MILLSTONE NUCLEAR POWER STATION, UNIT NOS. 1 AND 2

PROPOSED REVISIONS TO ENVIRONMENTAL TECHNICAL SPECIFICATIONS

JULY, 1980

FIGURE 5.1-1 Chart of Organizational Responsibilities for Northeast Utilities and the Northeast Nuclear Energy Company.

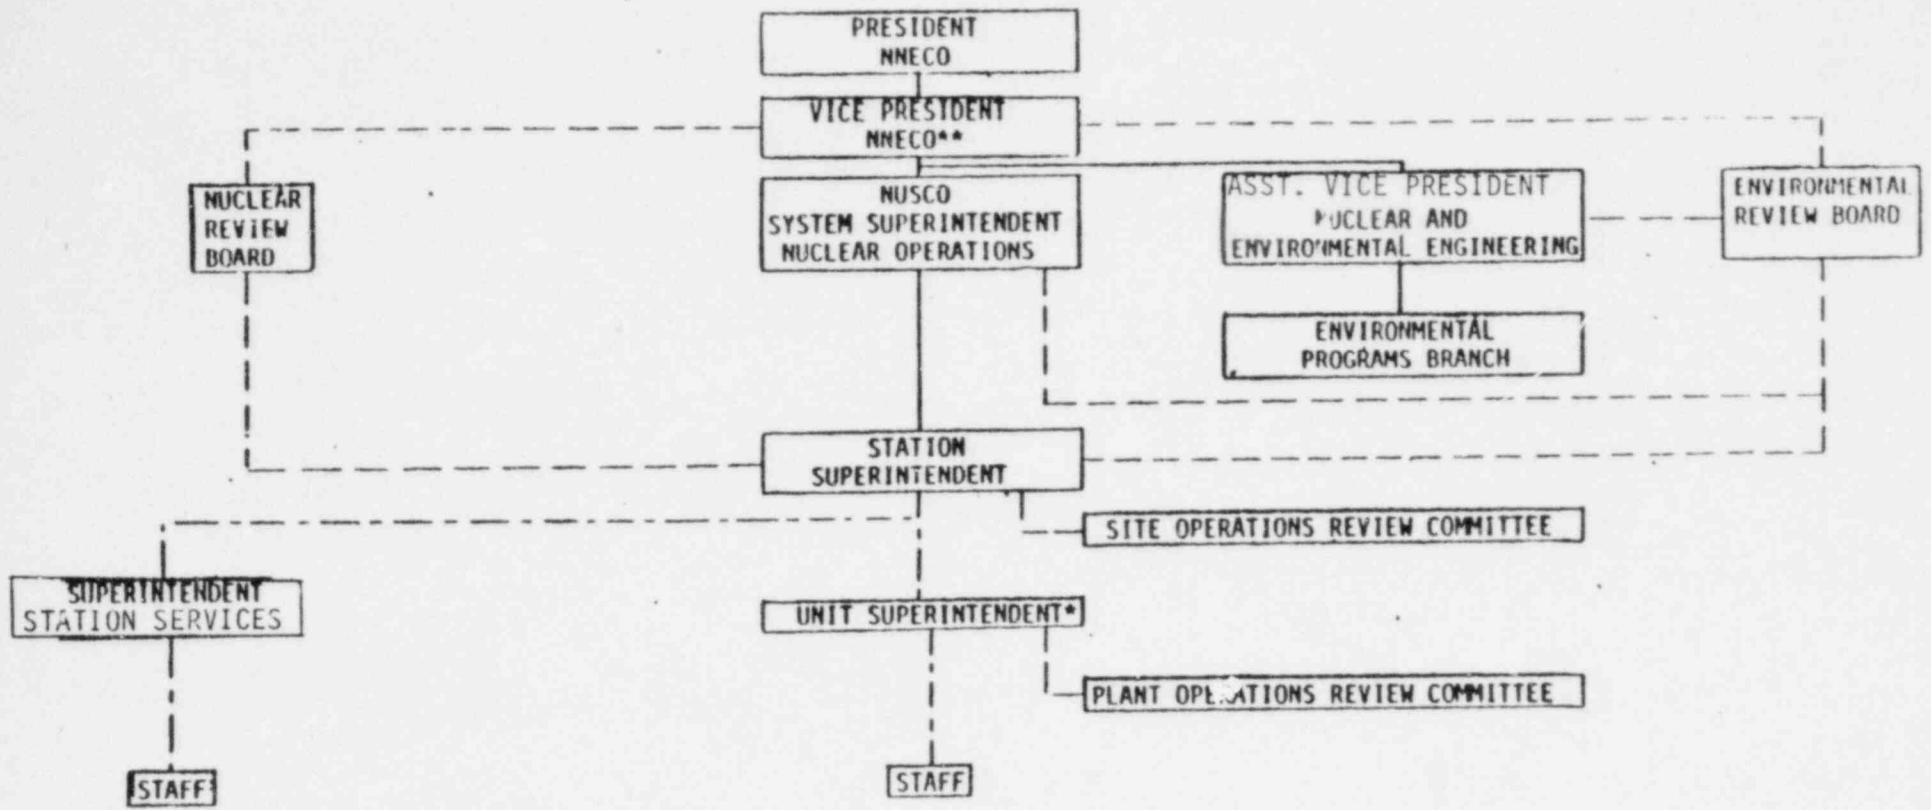
The ERB shall be advisory to the NUSCO Senior Vice President of Nuclear Engineering and Operations, the Station Superintendent, the NUSCO System Superintendent Nuclear Operations, and the NUSCO Assistant Vice President of Nuclear and Environmental Engineering as indicated in Figure 5.1.1.
